5/16/89

A000094

REACH 1

Revisions :

STA. 564 + 00

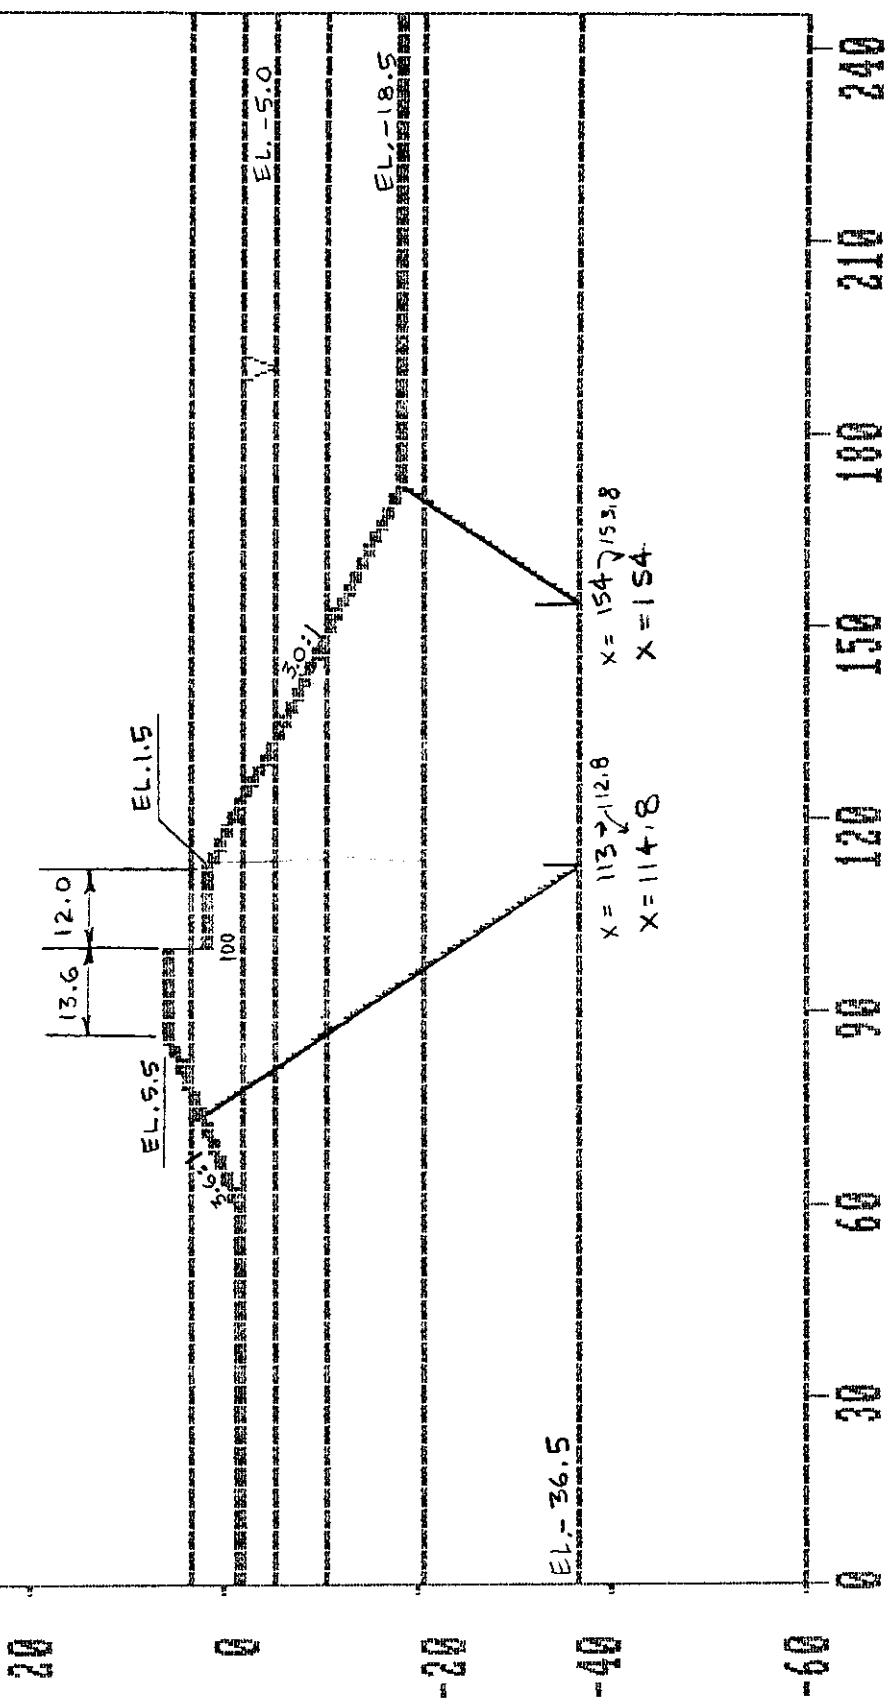
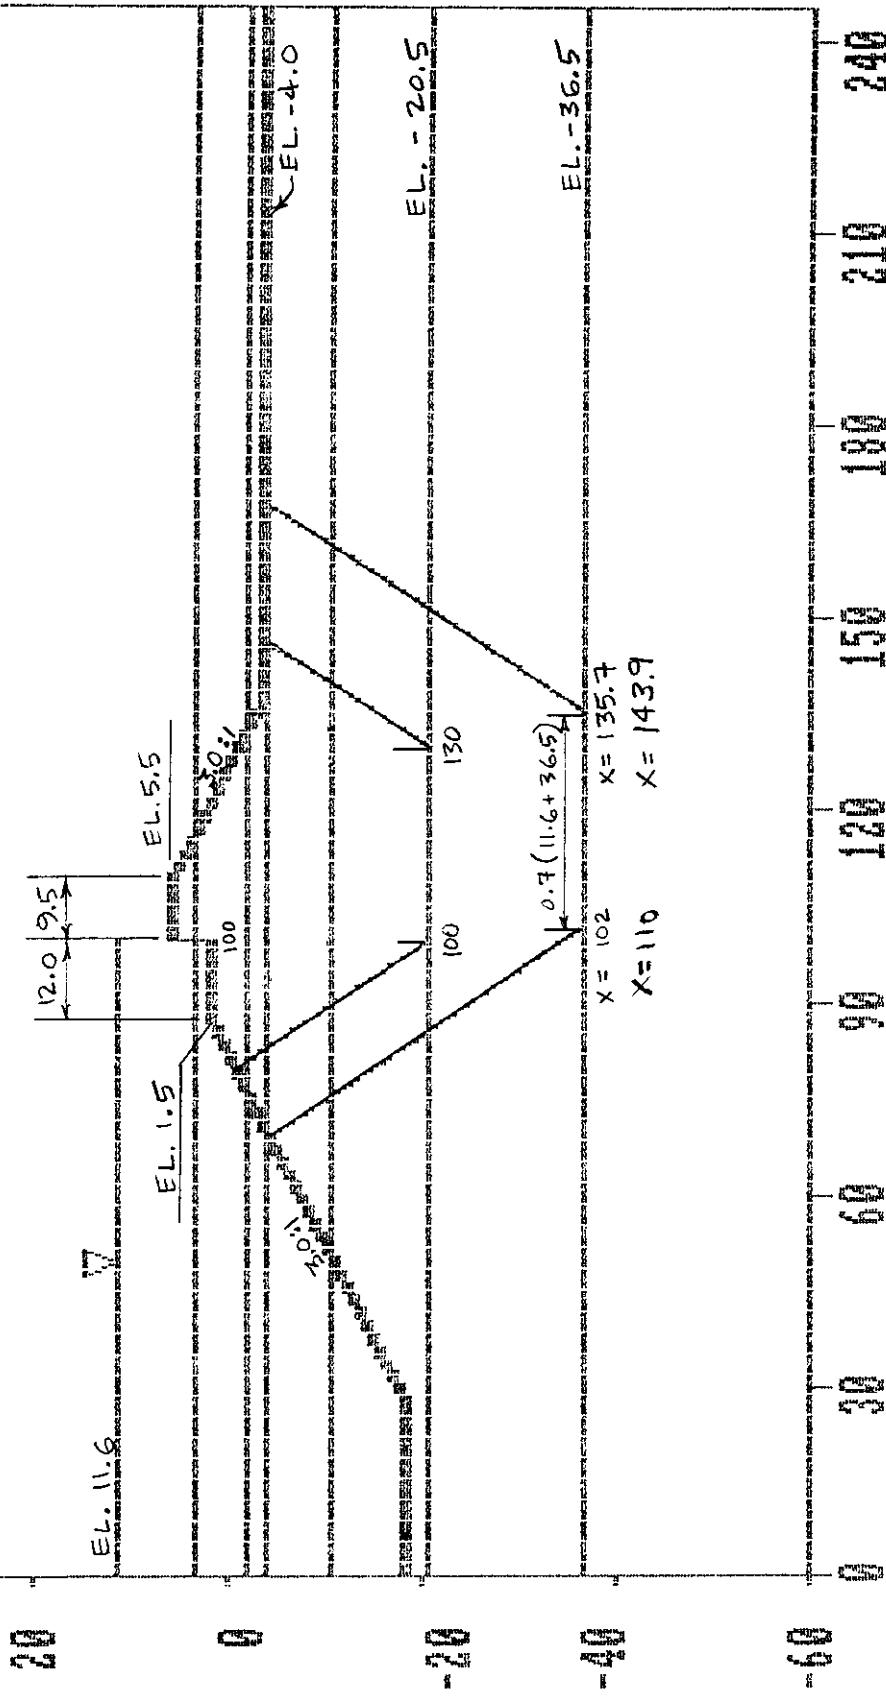
1. Entire sheet pile wall moved 0.5' closer to the canal thus increasing the crown width 0.5' along the entire reach.
2. Step elevation lowered from El. 2.0 to El. 1.5.

1. New canalside stability analyses taking into account the above revisions and the correction to the soil shear strength from El. 0.0 to El. -2.0.
2. New landside stability analyses taking into account the above revisions and including calculations at El. -20.5.
2. New sheet pile analyses taking into account the above revisions and the submerged canalside soil weight.

Canalside Failure - 562+00, 564+00 and 566+00. The section at Sta. 564+00 governs.
*** Minimum Factor of Safety = 1.32 at El. -36.5 ***

Landslide Failure - 554+00, 556+00, 560+00 and 562+00. The section at Sta. 560+00 governs.
*** Minimum Factor of Safety = 1.38 at El. -28.5 ***

STA. 570 + 00

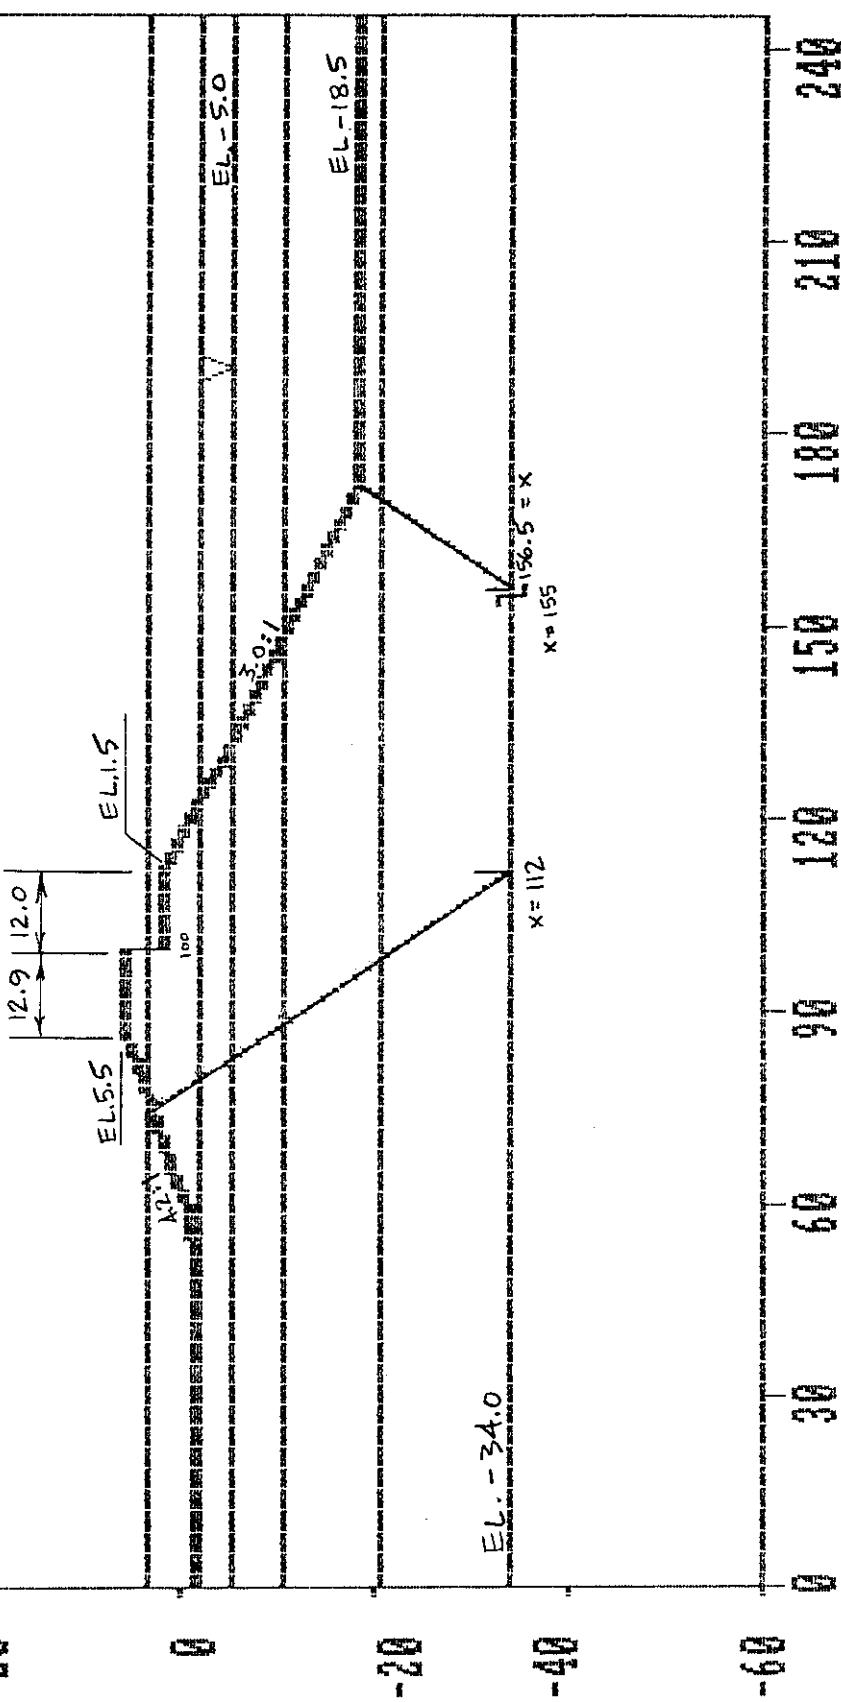
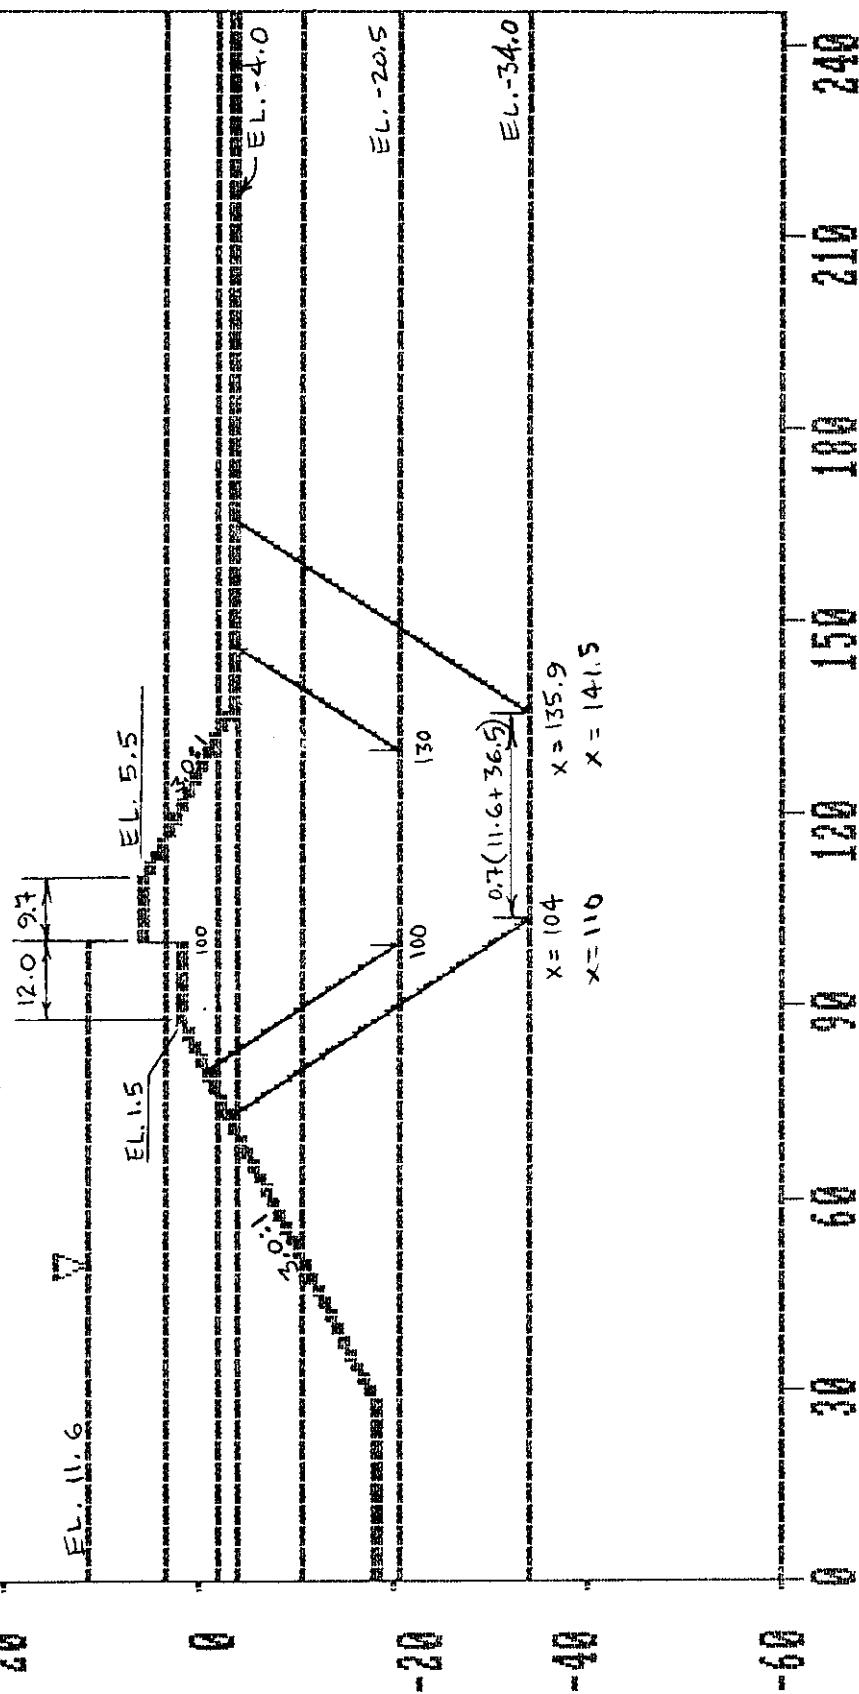
1. Entire sheet pile wall moved 0.5' closer to the canal thus increasing the crown width 0.5' along the entire reach.
2. Step elevation lowered from El. 2.0 to El. 1.5.
3. Step width increased from 9.0' to 12.0'.

1. New canalside stability analyses taking into account the above revisions and the correction to the soil shear strength from El. 0.0 to El. -2.0.
2. New landside stability analyses taking into account the above revisions and including calculations at El. -20.5.
3. New sheet pile analyses taking into account the above revisions and the submerged canalside soil weight.

*** Minimum Factor of Safety = 1.35 at El. -34.0 ft

*** Minimum Factor of Safety = 1.38 at El. -34.8 ***

STA. 612+00

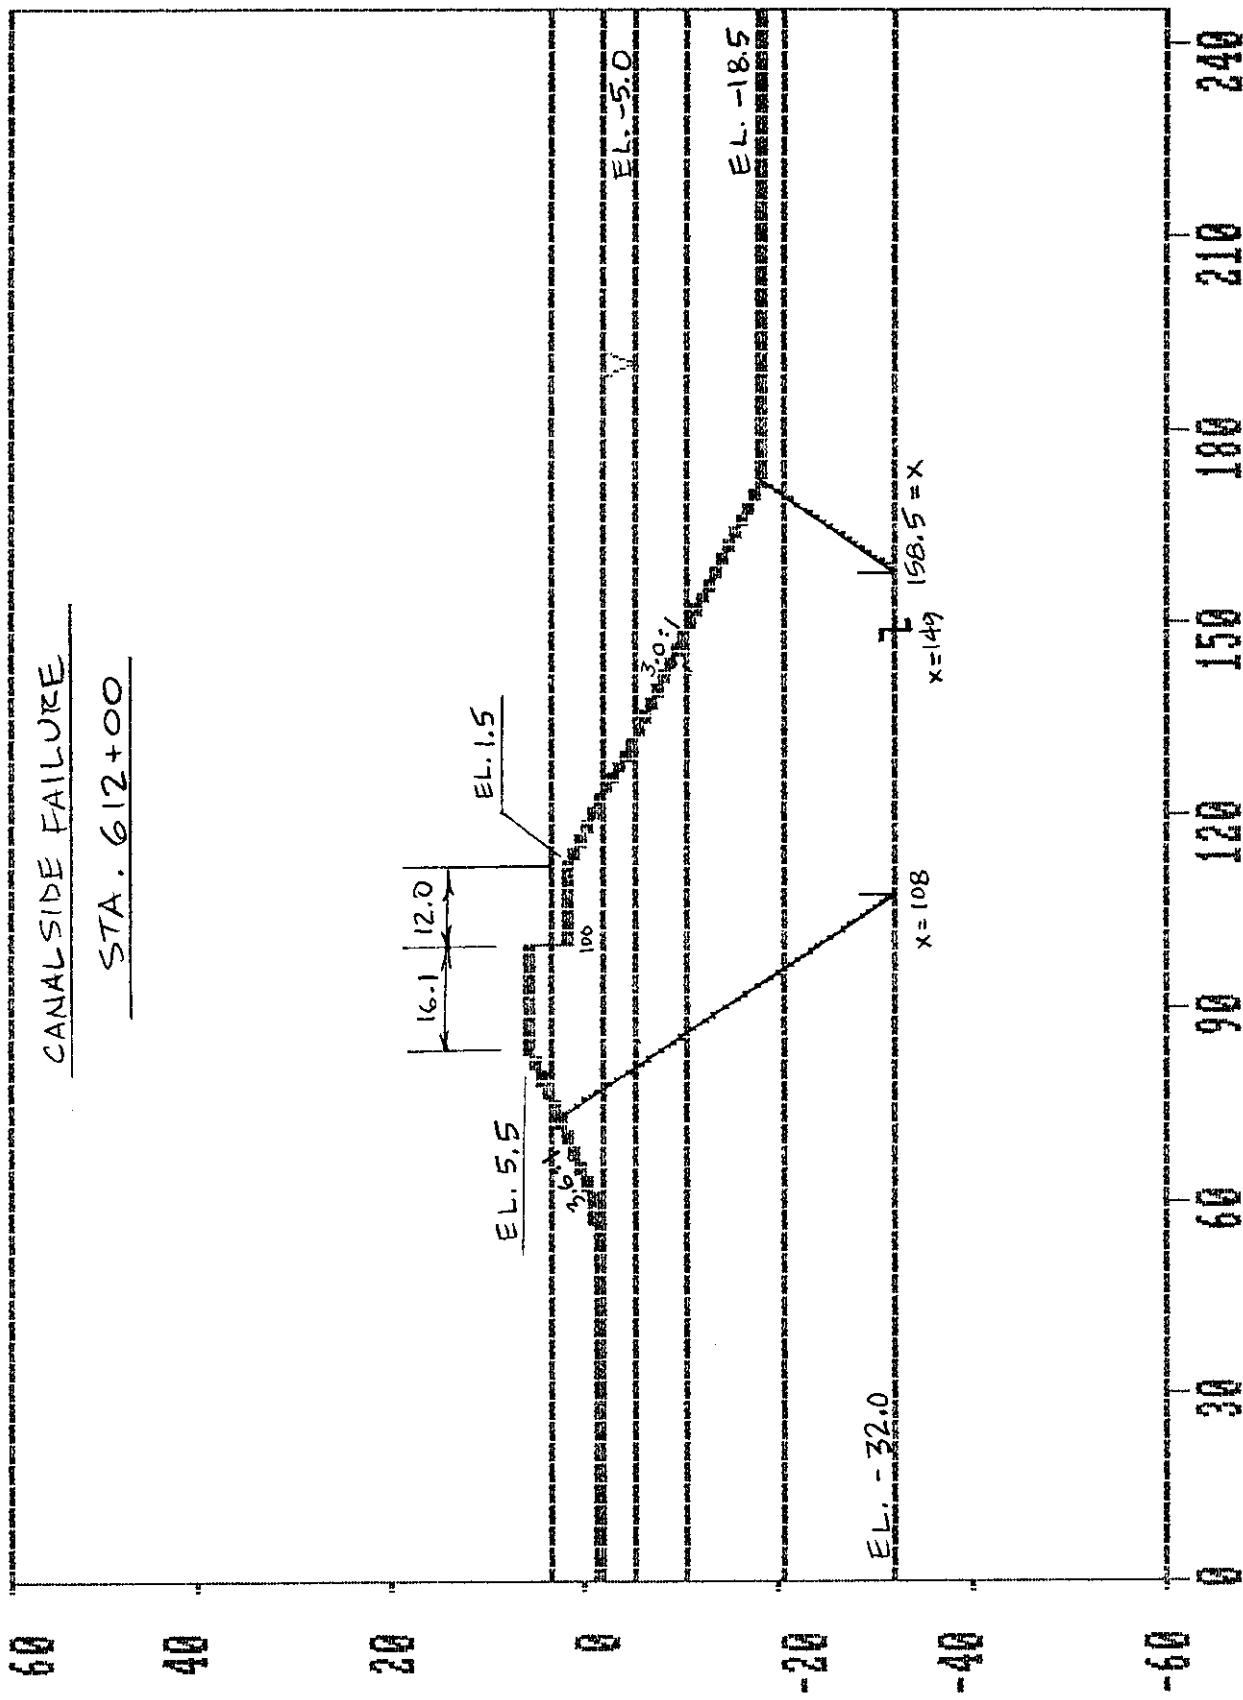
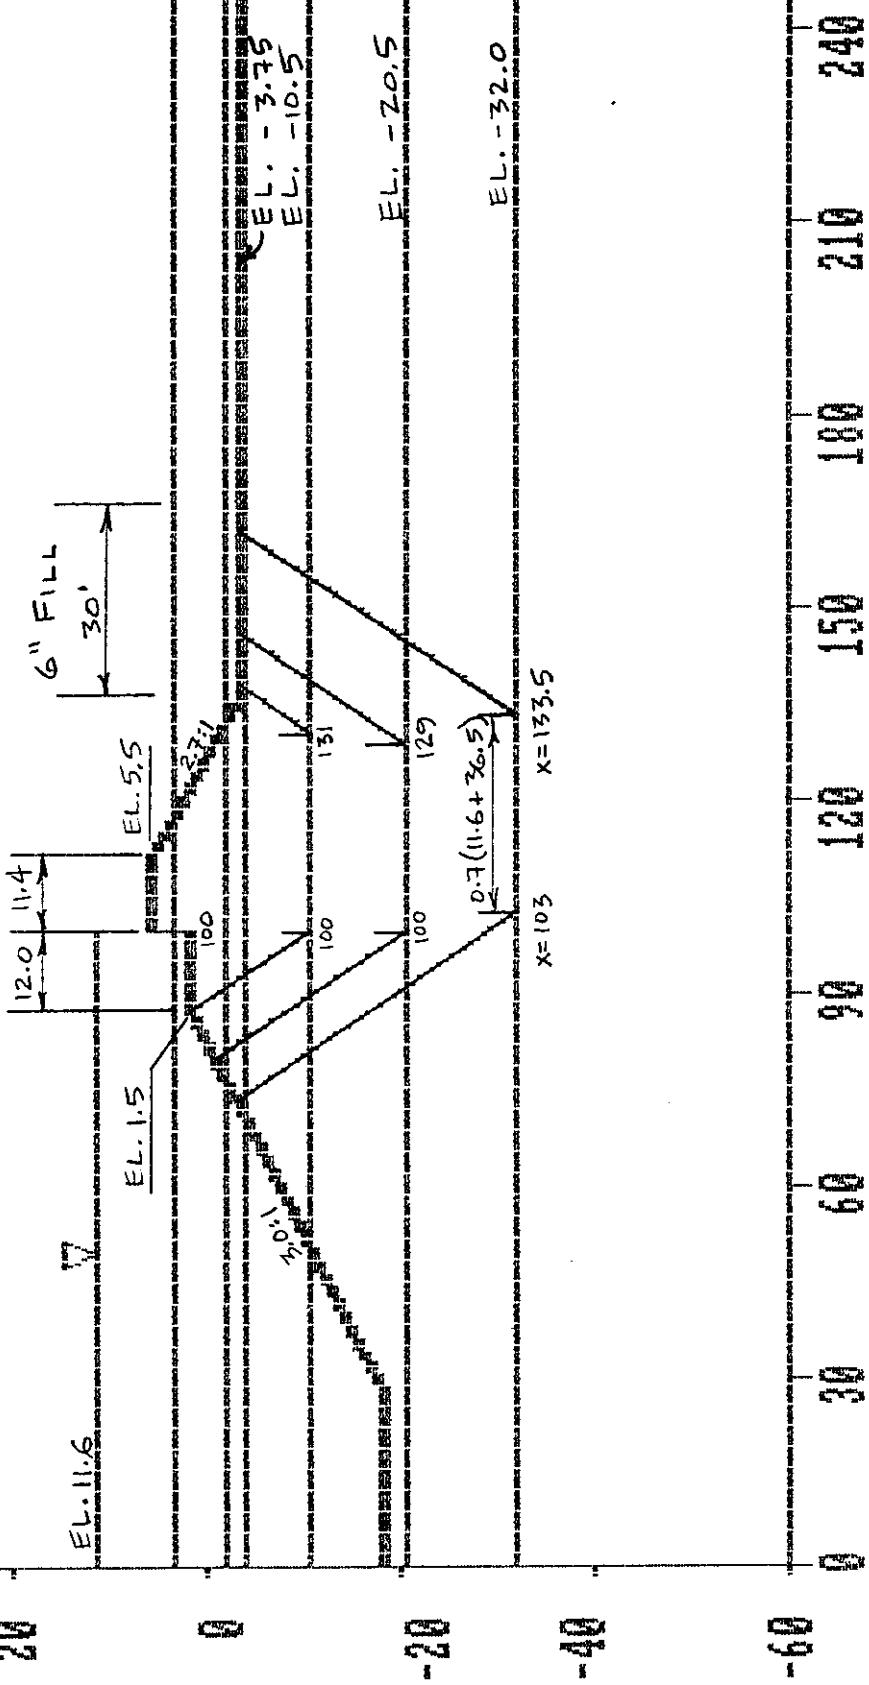
1. Entire sheet pile wall moved 0.5' closer to the canal thus increasing the crown width 0.5' along the entire reach.
2. Step elevation lowered from El. 2.0 to El. 1.5.
3. Step width increased from 9.0' to 12.0'.
4. Add 6" of fill from the levee toe to a distance 30' from the levee toe in the vacant lot referenced.

1. New canalside stability analyses taking into account the above revisions and the correction to the soil shear strength from El. 0.0 to El. -2.0.
2. New landside stability analyses taking into account the above revisions and including calculations at El. -10.5 and El. -20.5.
2. New sheet pile analyses taking into account the above revisions and the submerged canalside soil weight.

Reach 3 landside stability analysis at El. -32.0 with the active wedge at $x=110$ and the passive wedge at $x=140.5$ does yield a lower factor of safety than with the wedges at $x=111$ and 144.5 respectively, as previously submitted. However, it has since been discovered, that placing the active wedge at $x=103$ and the passive wedge at $x=133.5$ yields the lowest factor of safety. Therefore these calculations are being submitted in lieu of the requested location.

Canalside Failure - 612+00. *** Minimum Factor of Safety = 1.36 at El. -32.0 ***

Landside Failure - 598+00, 592+00, 594+00, 596+00, 600+00, 604+00 and 606+00. The section
at Sta. 604+00 governs. *** Minimum Factor of Safety = 1.38 at El. -28.5 ***
